TCP/11/16(477) – 17/00334/IPL – Residential development (in principle), site of former 1 Lower Gauls, Bankfoot

**TCP/11/16(477) – 17/00334/IPL – Residential development
(in principle), site of former 1 Lower Gauls, Bankfoot**

**PAPERS SUBMITTED
BY THE
APPLICANT**

NOTICE OF REVIEW

Proposed Section A-A through Plot No.1

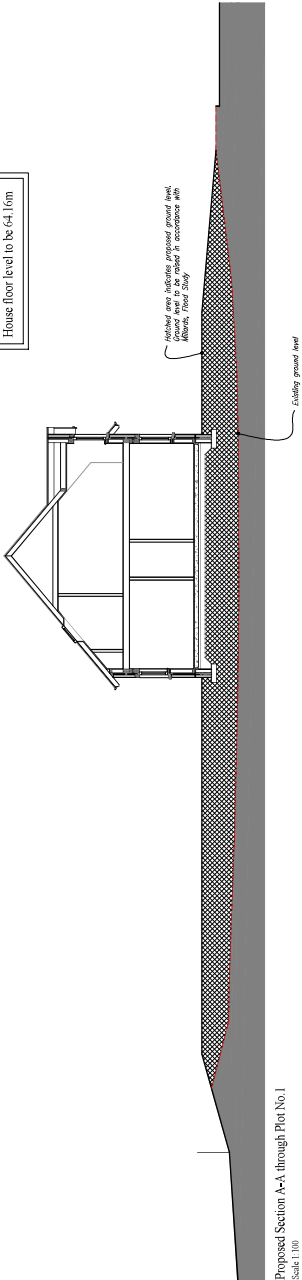
Plot 1
Garden ground raised to 63.86m
House floor level to be 64.16m

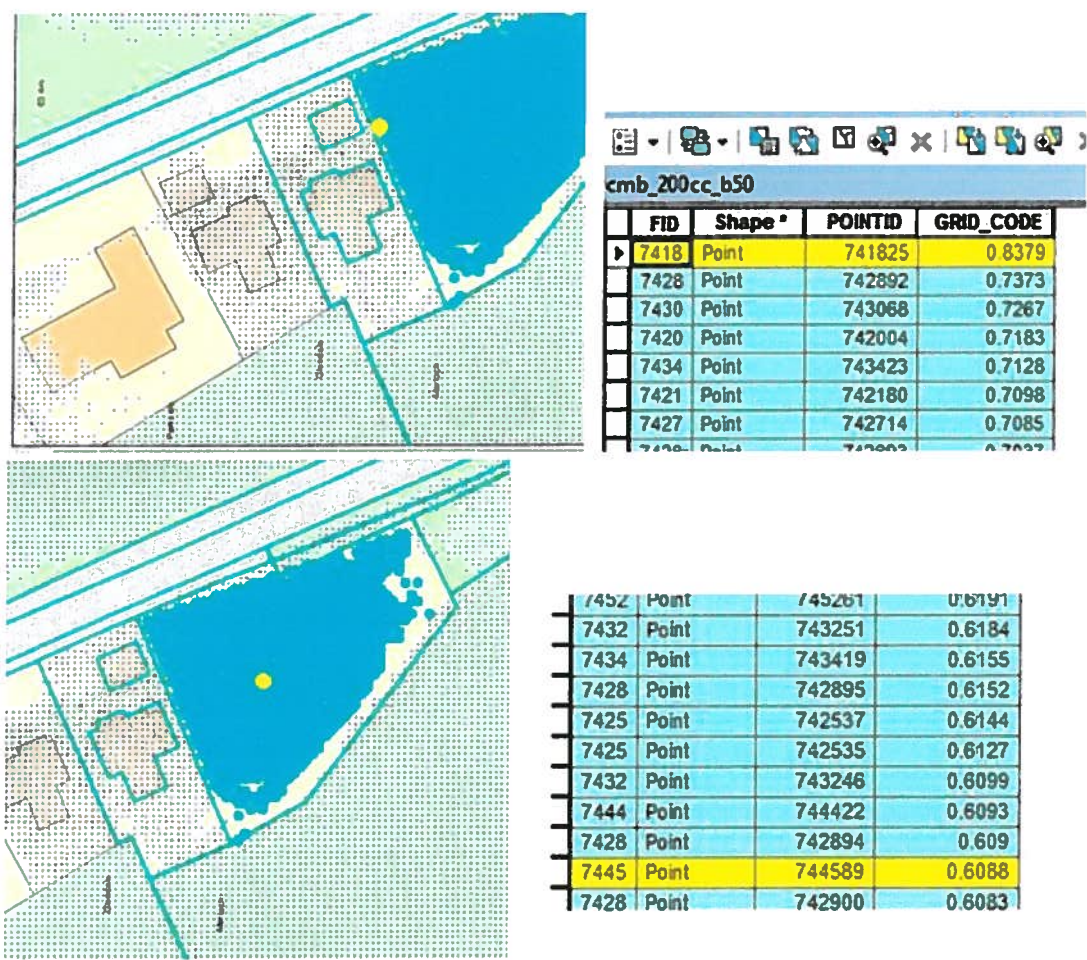
- ☐ Based on the mapping you included in your document, the 200 year + cc flood level predicted by Halcrow is between 600 and 840mm approximately:

I would comment that

*These levels are at the lowest points in the garden and are immediately adjacent to the existing cottage. This is exactly the problem discussed above regarding the vulnerability of the existing cottage.

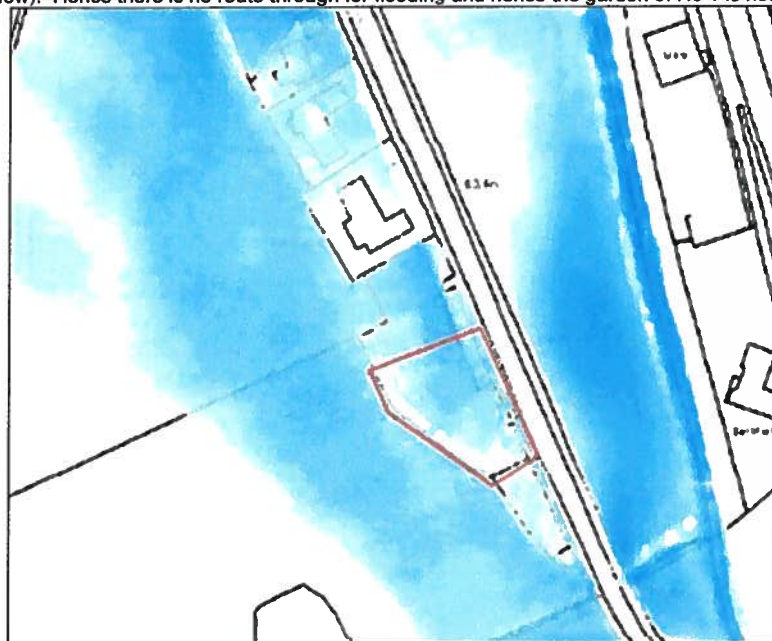
- In the 1 in 100 year + 25% blockage flood mapping also appended to your document, it is quite surprising to note the two houses next door are within the floodplain. This may explain why you view the garden of No 1 to be part of the functional floodplain, as there is a route

through for flooding from next door. However, this is based on outdated LIDAR data, the houses next door have been built since the early drafts of the Halcrow report, and are as previously mentioned built up to above road level (see photo of boundary between No1 and its neighbour below). Hence there is no route through for flooding and hence the garden of No 1 is not continuous with any floodplain.

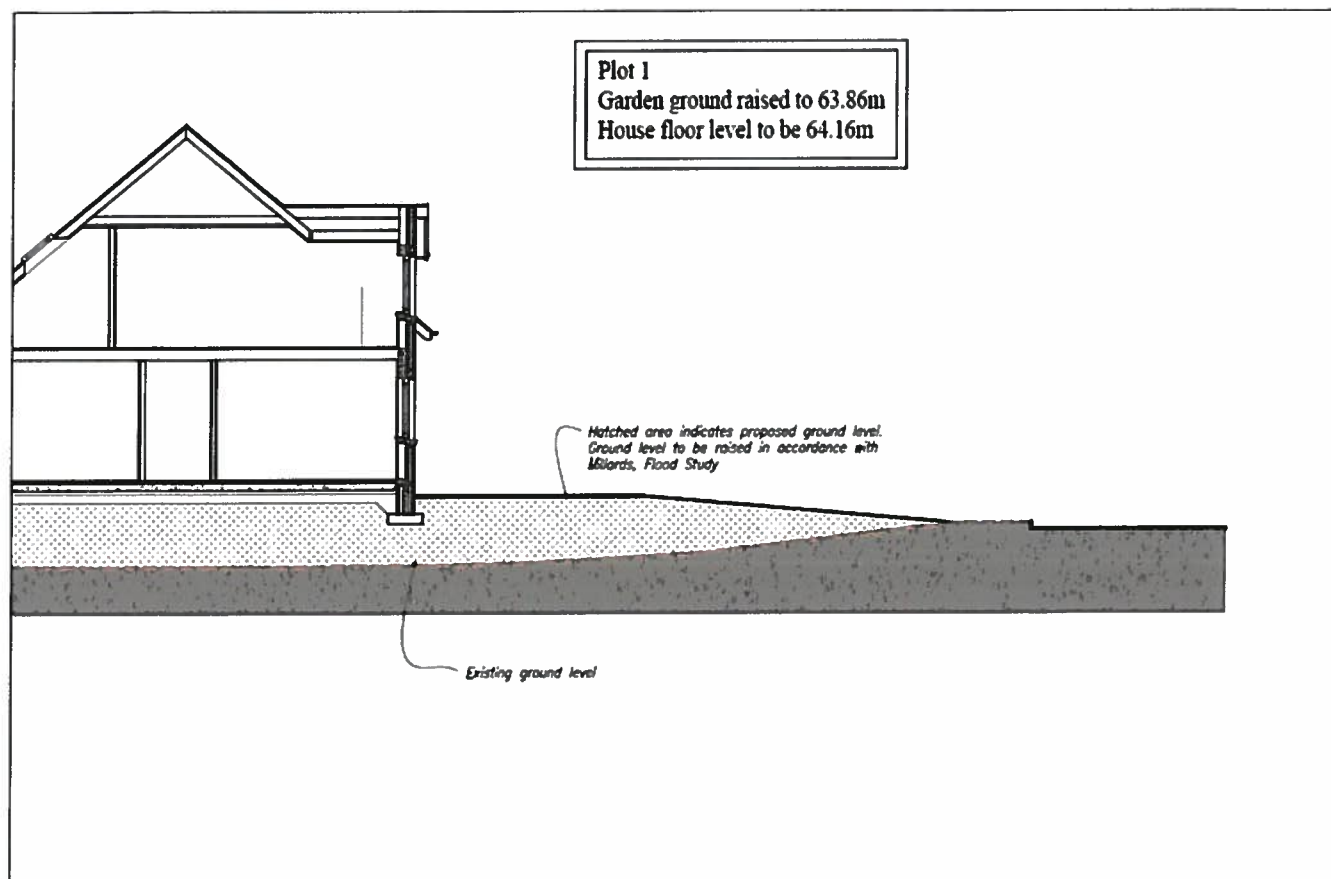
In your report you state "The applicant does mention raising the ground – but no details are provided on this – to be in line with our current guidelines new developments need to be sited above the 1:200 year + cc level + 600mm freeboard allowance." However we do actually recommend a finished floor level of 63.86m in our report, and this is included in the architect's drawings submitted to planning, an excerpt of which is shown below. As discussed in our original FRA report, the garden ground level was used for the houses built next door, and was intended to be 300mm above the 200 year flood, and the FFL was intended 600mm above the 200 year flood level. As you have mentioned, we would currently include climate change when considering freeboard, however the Halcrow report assessed a lower flood level than our 2008 report, so these levels may already comply. If you could advise what the current predicted 200 + cc level is, we would be happy to revise up the recommendation for minimum FFLs. Regarding the garden ground, we would prefer to keep to the same level as the neighbouring plot to avoid any possibility of runoff from the development site to the existing gardens next door.

- In the architect's plans, I note the raised ground includes the area to the south where the proposed foul soakway is proposed. It would be possible to lower this to the Q200 level in this area
- I note your comments re sewer flooding. This is an area we were not asked to on in our report. I would suggest that sewer flooding is an inherent problem for this site because the existing cottage is very low lying. If new housing were built as suggested, these problems would be solved. I am not aware of any problems with the neighbouring houses.
- I note your comments re the recommended use of flood resilient methods and materials. Although the proposed houses would be well above predicted flood levels, I accept that this is an appropriate measure.
